KEWAUNEE NUCLEAR POWER PLANT

Amendment No. 21  
License No. DPR-43

ATTACHMENT TO LICENSE AMENDMENT NO. 21

SUPPORTING AMENDMENT NO. 21 TO LICENSE NO. DPR-43

FIGURE TS 3.10-3 Amendment No. 21

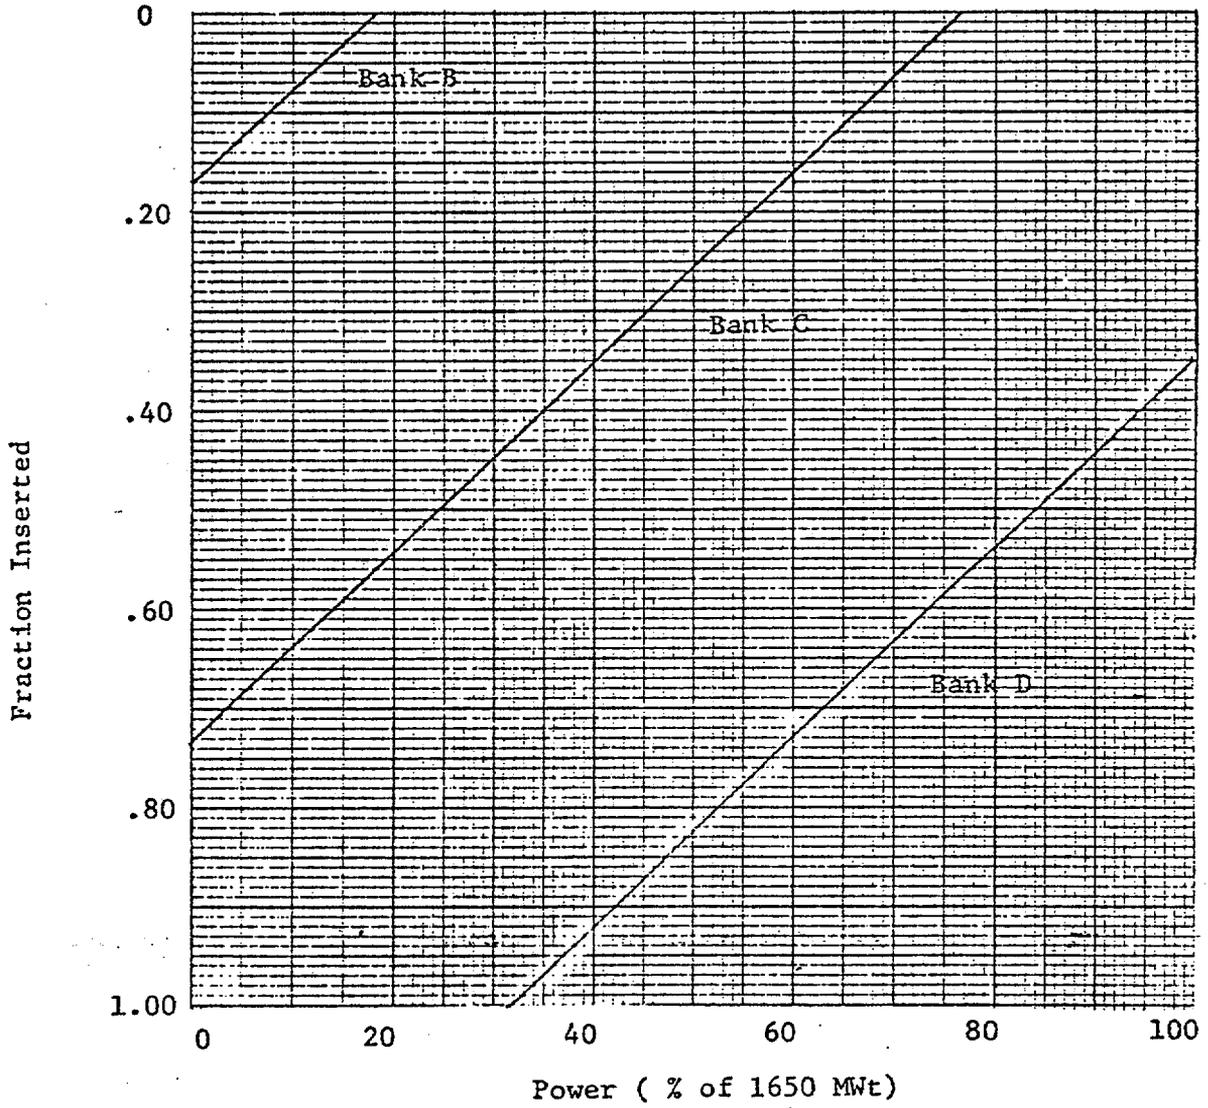
1. The shutdown rods shall be fully withdrawn when the reactor is critical or approaching criticality.
2. The control banks shall be limited in physical insertion; insertion limit is shown in Figure TS 3.10-4. Core 4 insertion limits shall be in accordance with Figure TS 3.10-3 to assure sufficient shutdown margin for the cycle.
3. Insertion limit does not apply during physics tests or during periodic exercise of individual rods. However, the shutdown margin indicated in Figure TS 3.10-1 must be maintained except for the low power physics test

Trip shutdown reactivity is provided consistent with plant safety analysis assumptions. To maintain the required trip reactivity, the rod insertion limits of Figure TS 3.10-4 must be observed. In addition, for hot shutdown conditions, the shutdown margin of Figure TS 3.10-1 must be provided for protection against the steambreak accident. To assure adequate at power shutdown margin during operation of Core 4, the shutdown margin of Figure TS 3.10-3 shall apply.

It has been proposed that Figure TS 3.10-3, "Control Rod Insertion Limits as a Function of Power, Kewaunee Nuclear Plant, Unit 1 - Cycle 4" be amended to restrict bank D insertion at power. The change reduces the control bank bite insertion allowance and in turn increases the scrammable reactivity available at hot full power. The proposed amendment is conservative and prudent.

The amendment incorporates changes to Appendix A Technical Specifications to support operation in Cycle 4. The Technical Specification limiting control rod insertion during power operation is changed to maintain the shutdown margin required near end of Cycle 4 operation.
